SUBJECT: **ACCC STAIRWELL EGRESS CONTROL PLAN – GENERAL CONTRACTORS AS NEEDED
ADDENDUM #3**

RFI Responses

OBSTRUCTED MAGNET EXIT DOOR -
CORRIDOR SIDE

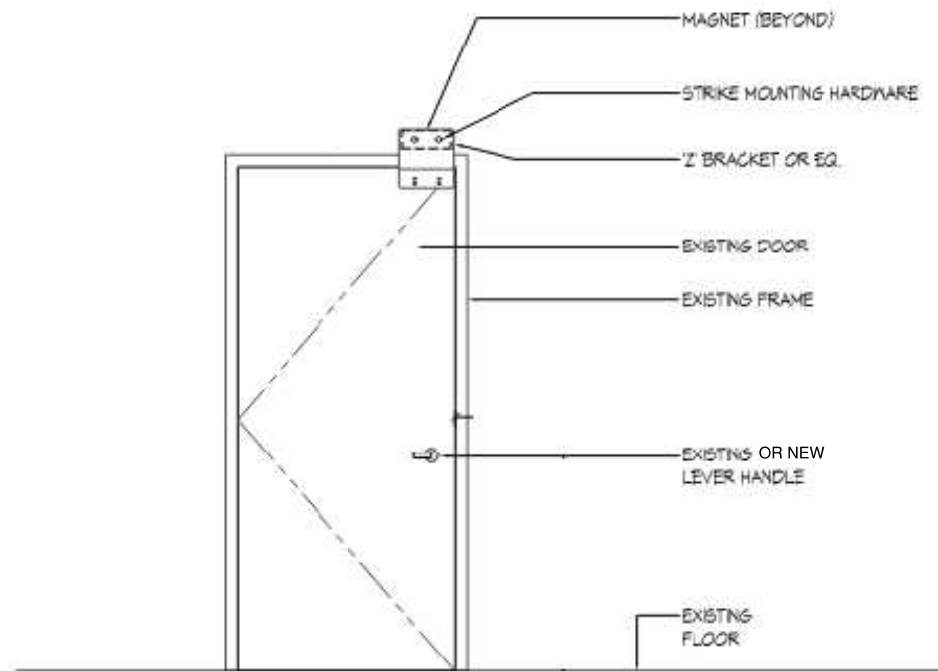
1. Could you please specify the magnetic lock locations and how they tie into the existing system on specifically the convention center doors, and any other affected doors.
Magnetic locks are to be typically placed on the push side of doors. In the event that the push side is obstructed by a beam or other obstruction, the magnet may be placed on the pull side of the door, utilizing the brackets shown in the attached details. Note that the mag lock has an integral motion detector. Any door getting a bracket and pull side mag lock, will need an additional motion detector mounted on the push side. See electrical drawings for how locks tie into existing systems.

2. During the walkthrough we noticed the doors in the Convention Center space had steel beams running across the heads of the door. We would need to know where the maglocks are being mounted for those sets of doors.
See response to item 1 above.
